**INFOTECH R5 - 17-04c**

**Sujet : pop-off 2017**

### **Sujet : insert pop-off**

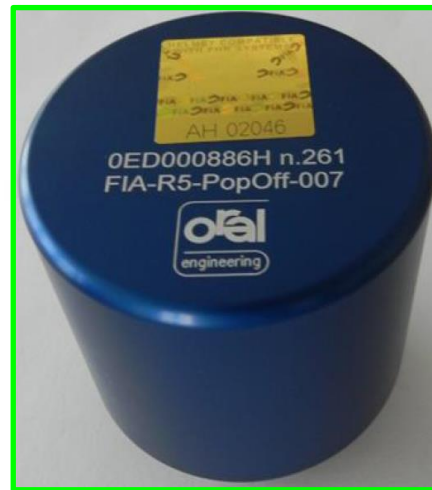
Vous pourrez trouver sur le site de la FIA la mise à jour de la « Liste technique FIA n°43 » relative aux soupapes pop-off homologuées, en date du 15 mai 2017 :

Les soupapes ref FIA-R5-PopOff-006 peuvent modernisées gratuitement par Oral Engineering pour en faire des pop-off 007, conformes.

We would like to inform you the FIA "Technical List n°43" (list of homologated pop-off) has been updated the 15<sup>th</sup> of Mai 2017, and is now online at:

The boost control system part nb FIA-R5-PopOff-006 can be upgraded to part nb FIA-R5-PopOff-007, for free by Oral Engineering so that they comply with the current FIA technical list.
